PROJECT TITLE:
 DEHDASHT PETROCHEMICAL INDUSTRY COMPANY
 DEHDASHT HIGH DENSITY POLYETHYLENE PROJECT

DRAWING TITLE:
 PIPING AND INSTRUMENT DIAGRAM (P&ID)

DOCUMENT No:
 DPIC9812-000-VD-1002-ME-PID-0010

PAGE NO. 611B-0

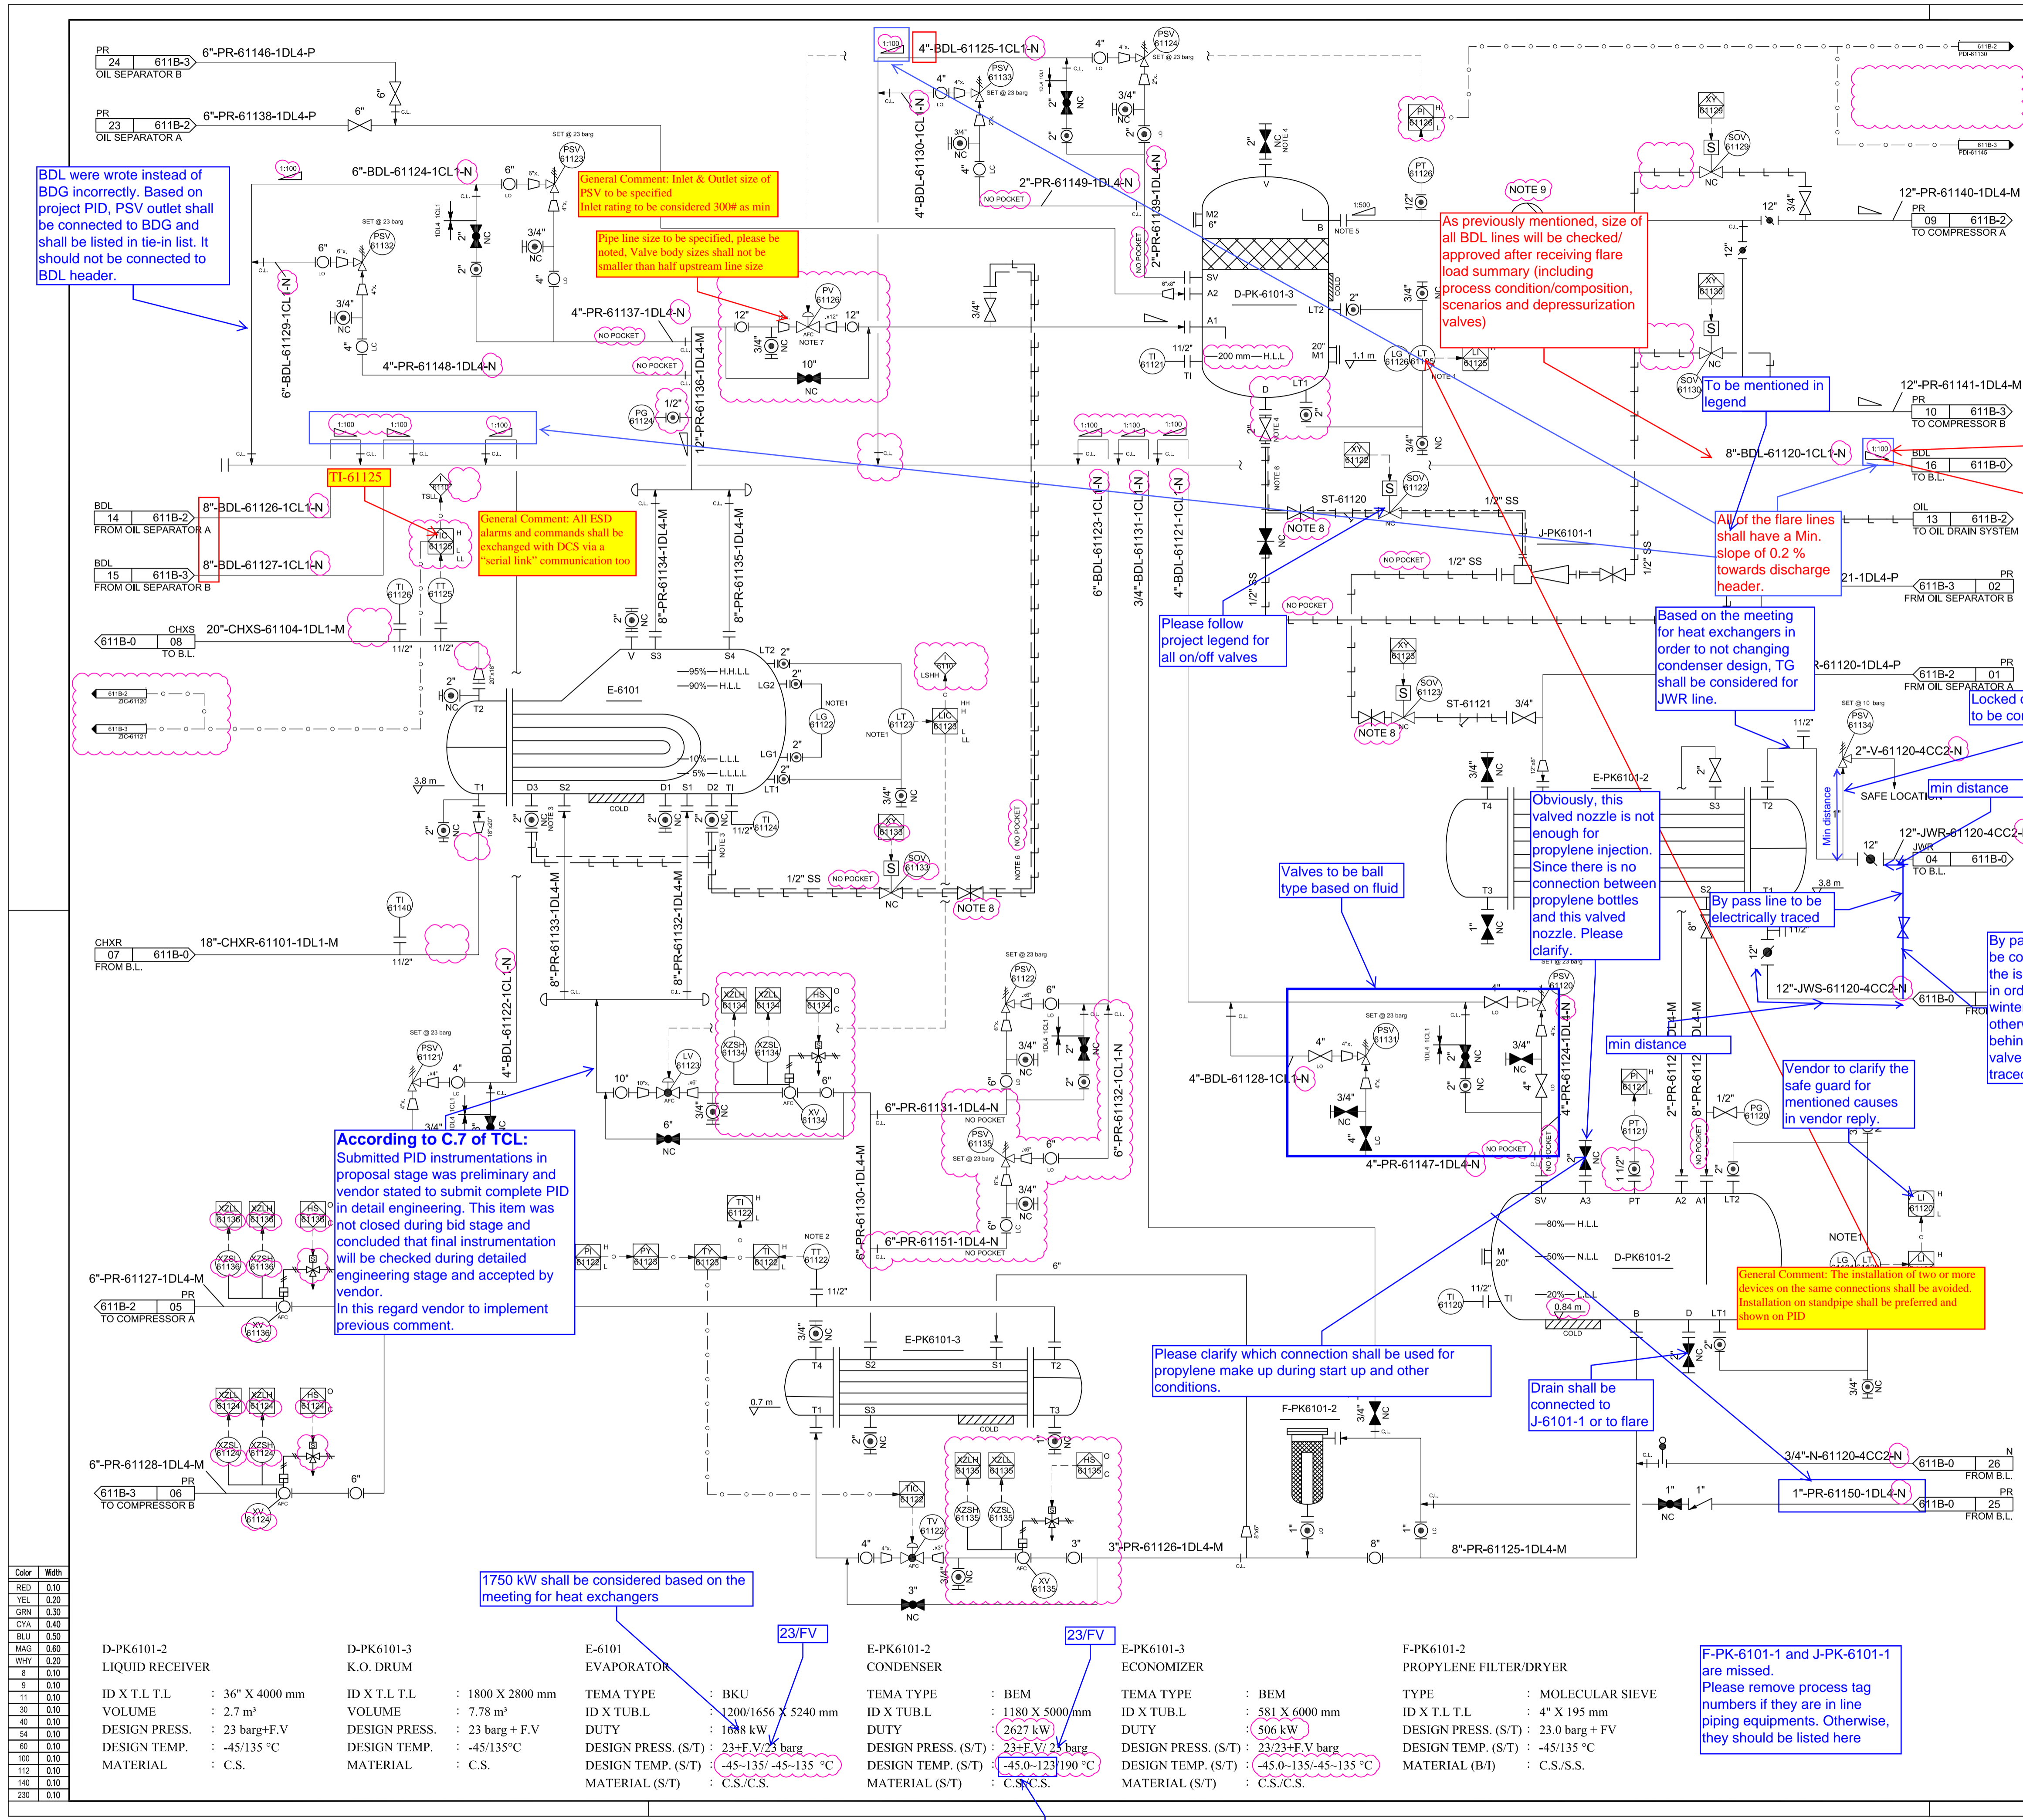
general comment:
 -trim line number for all equipment shall be added.
 -next to serial number for all lines inside package (PK) shall be marked
 -Pipe class of lines will be checked after receiving stream list in the next revision
 -Previous comment about adding line no. shall be considered by vendor
 -Pipe class of tie in which has not been shown in project PID, will be checked later
 -Pipe class of lines will be checked after receiving stream list in the next revision

NOTE 9: As previously mentioned, size of all BDL lines will be checked/ approved after receiving flare load summary (including process condition/composition, scenarios and depressurization valves)

NOTE 10: Obviously, this valved nozzle is not enough for propylene injection. Since there is no connection between propylene bottles and this valved nozzle. Please clarify.

NOTE 11: Vendor to clarify the safe guard for mentioned causes in vendor reply.

NOTE 12: General Comment: The installation of two or more devices on the same connections shall be avoided. Installation on standpipe shall be preferred and shown on PID

NOTE 13: F-PK-6101-1 and J-PK-6101-1 are missed. Please remove process tag numbers if they are in line piping equipments. Otherwise, they should be listed here

NOTE 14: Please clarify which connection shall be used for propylene make up during start up and other conditions.

NOTE 15: Drain shall be connected to J-6101-1 or to flare

NOTE 16: 1750 kW shall be considered based on the meeting for heat exchangers

NOTE 17: According to C.7 of TCL: Submitted PID instrumentations in proposal stage was preliminary and vendor stated to submit complete PID in detail engineering. This item was not closed during bid stage and concluded that final instrumentation will be checked during detailed engineering stage and accepted by vendor. In this regard vendor to implement previous comment.

NOTE 18: PID approval will be after below documents submission:
 1- Approved Data sheets
 2- Process & start up procedure
 3- Capacity control philosophy
 4- Interlock description / cause and effect

NOTE 19: Vendor to collect all hydrocarbon drains and connect to flare

NOTE 20: Important comment: Package will be installed on the ground, so free draining of lines to flare network is not possible, please consider this matter

NOTE 21: Based on General Specification for Instrumentation "On-off and throttling control valves operated by safety and interlocking system shall be generally equipped with limit switch, to show valve position on DCS. Limit switches shall be valve shall be arm".

NOTE 22: Control Valve sized and relevant , Block & Bypass will be finalized after receiving relevant calculations and DSH.

NOTE 23: PSV sizes shall be frozen after final data sheet and calculations.

NOTE 24: Instrument process connections shall be as per DPC-IN-SPC-007

NOTE 25: Interlock connection and signals type will be finalized after receiving Control Philosophy.

NOTE 26: signals of Electro-Motors shall be modified based on P&ID legend.

NOTE 27: 8-All common Tag names shall be same as reference project P&ID.

NOTE 28: 9-Individual page shall be considered for interface signals between PLC and DCS/ESD.(All interface signals shall be clearly mentioned).

NOTE 29: 10- Indication on DCS of all signals shall be mentioned on P&ID by using proper symbol.(Above page mentioned)

NOTE 30: PID approval will be after finalization of all items

NOTE 31: Although vendor approval for following project legend, still there are some discrepancies. Vendor shall follow project legend in Lines (specially electrically tracing lines), valves (on/off valves for example), instrument logic symbol, equipments and ect.

NOTE 32: To be mentioned in legend

NOTE 33: All of the flare lines shall have a Min. slope of 0.2 % towards discharge header.

NOTE 34: Based on the meeting for heat exchangers in order to not changing condenser design, TG shall be considered for JWR line.

NOTE 35: Valves to be ball type based on fluid

NOTE 36: By pass line to be electrically traced

NOTE 37: By pass line shall be considered near the isolation valve in order to winterizing, otherwise all lines behind the isolation valve shall be traced.

NOTE 38: Locked open valve to be considered

PAGE NO. 611B-1

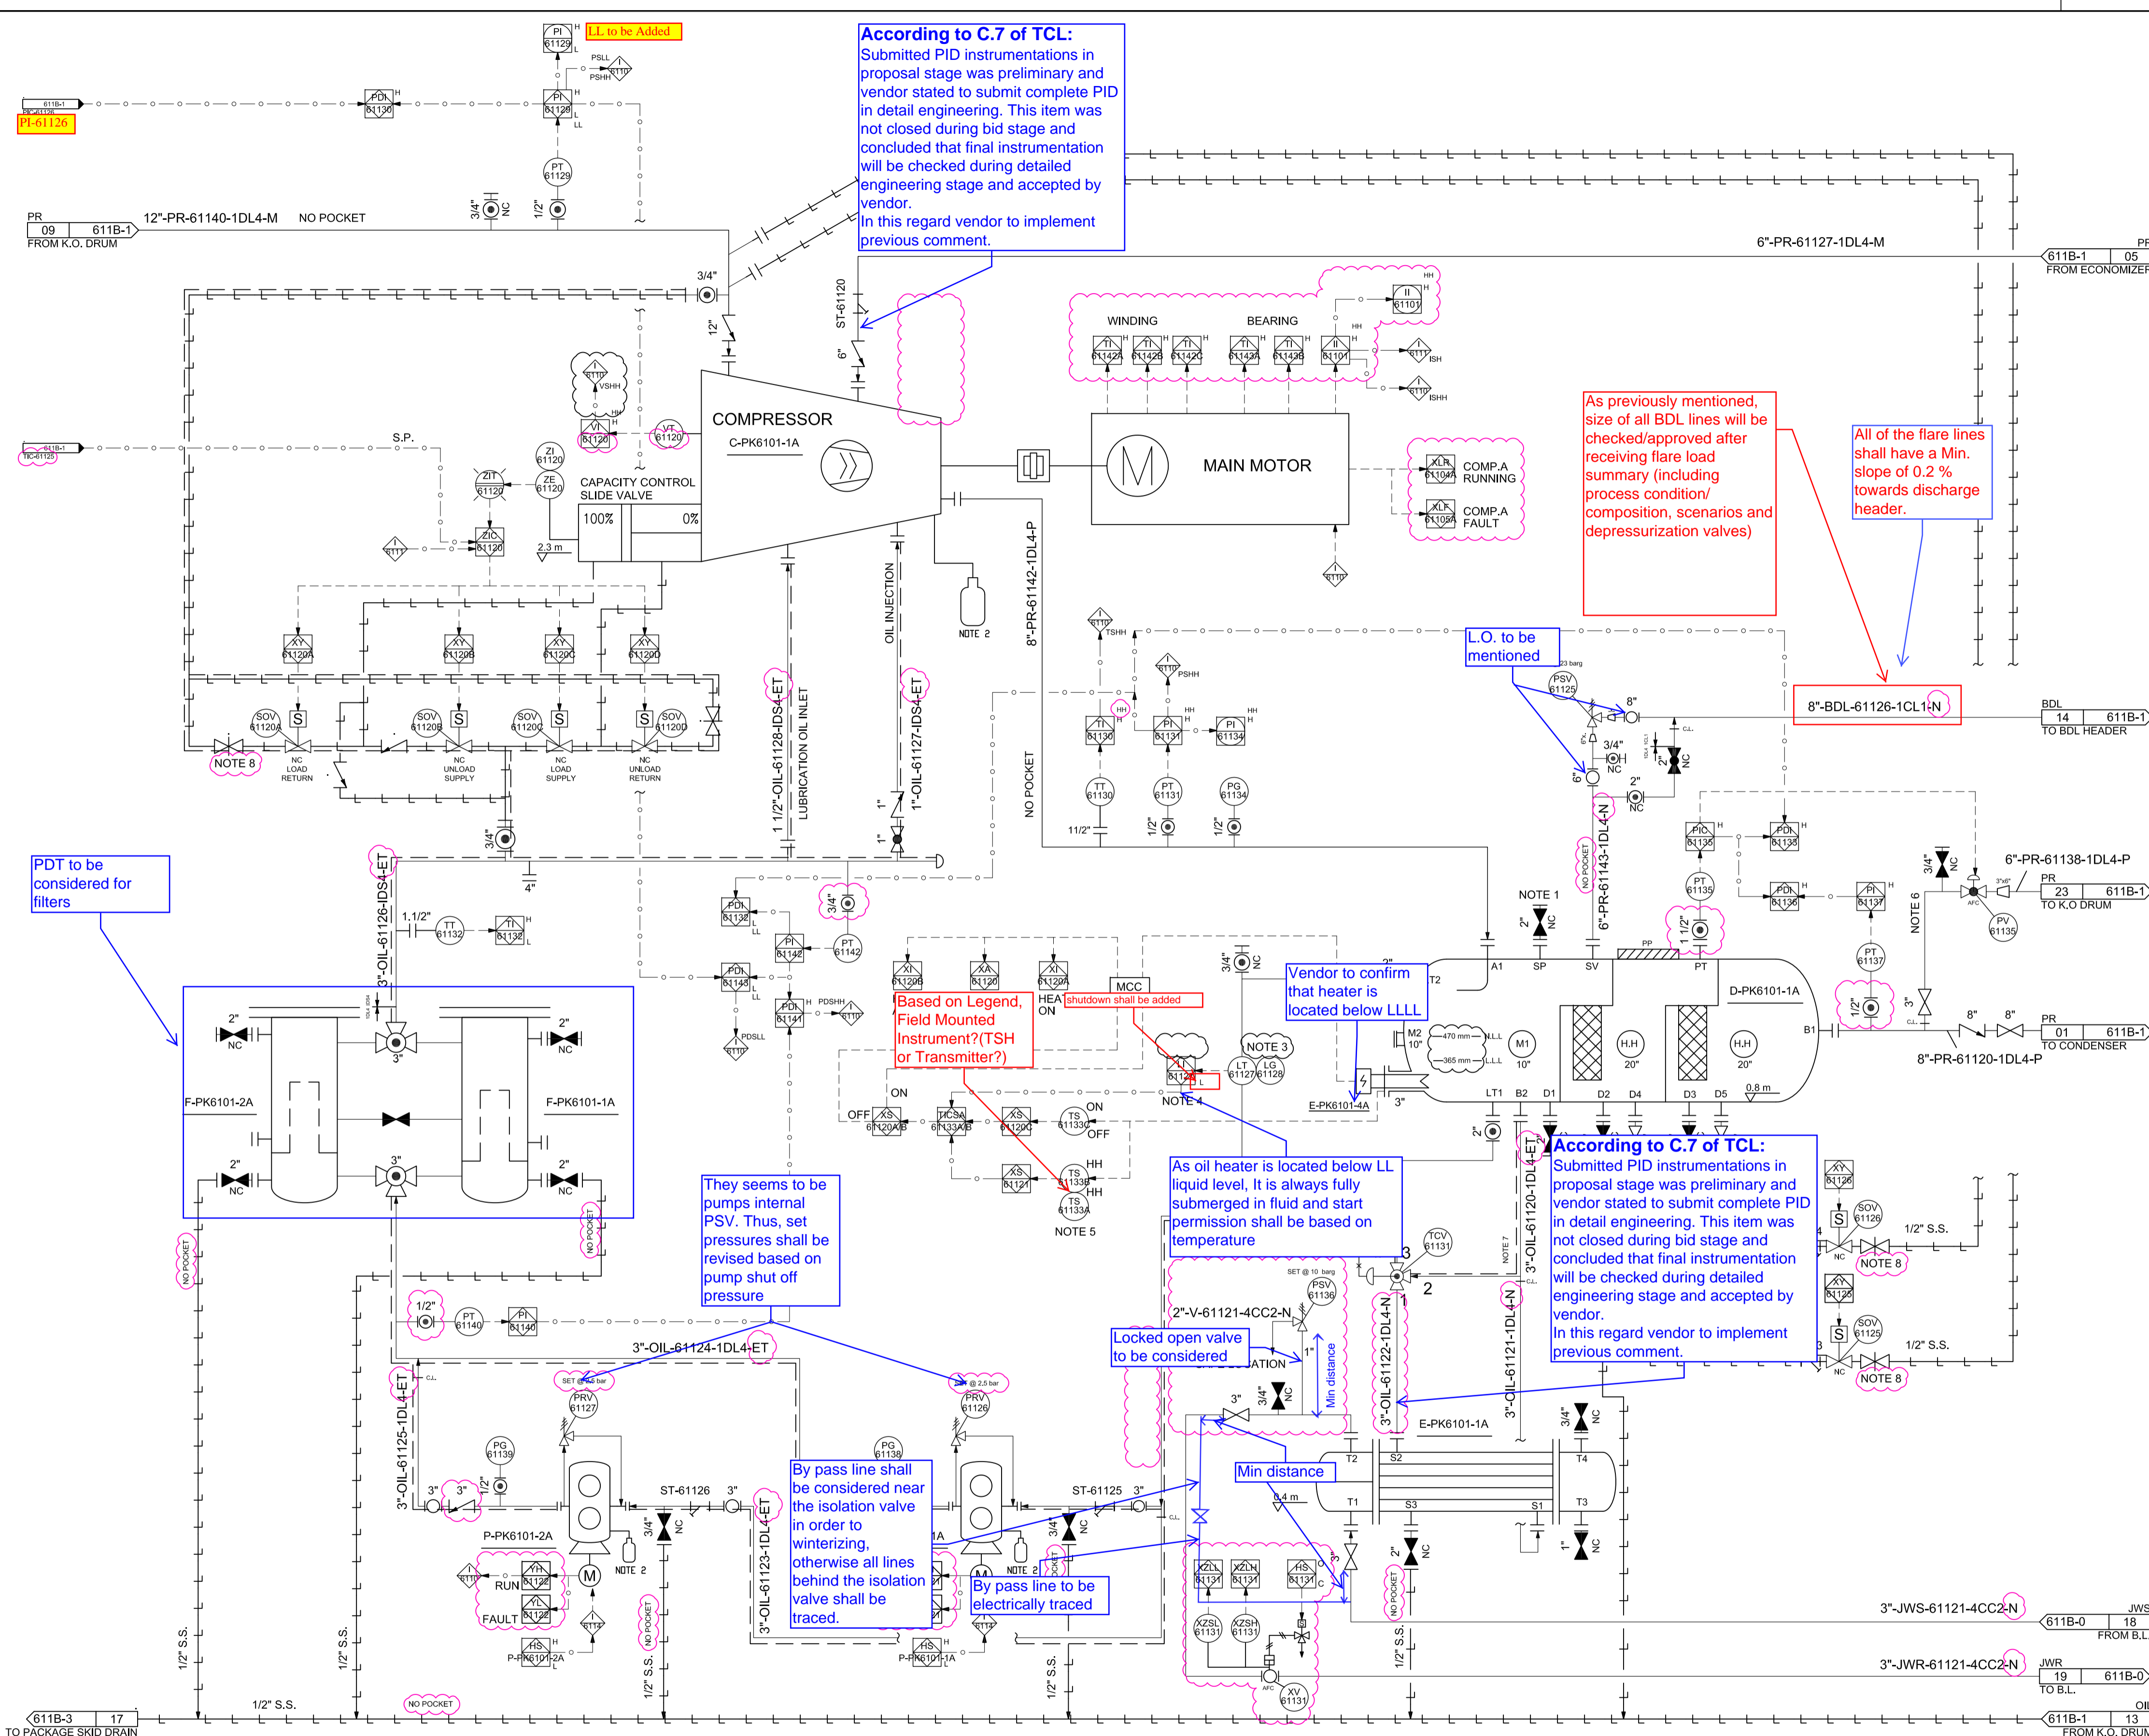
please clarify magnet type level transmitter, displacer or DP could be used as per project spec.

BDL were wrote instead of BDG incorrectly. Based on project PID, PSV outlet shall be connected to BDG and shall be listed in tie-in list. It should not be connected to BDL header.

General Comment: Inlet & Outlet size of PSV to be specified Inlet rating to be considered 300# as min

Pipe line size to be specified, please be noted, Valve body sizes shall not be smaller than half upstream line size

General Comment: All ESD alarms and commands shall be exchanged with DCS via a "serial link" communication too

According to C.7 of TCL: Submitted PID instrumentations in proposal stage was preliminary and vendor stated to submit complete PID in detail engineering. This item was not closed during bid stage and concluded that final instrumentation will be checked during detailed engineering stage and accepted by vendor. In this regard vendor to implement previous comment.

F-PK-6101-1 and J-PK-6101-1 are missed. Please remove process tag numbers if they are in line piping equipments. Otherwise, they should be listed here
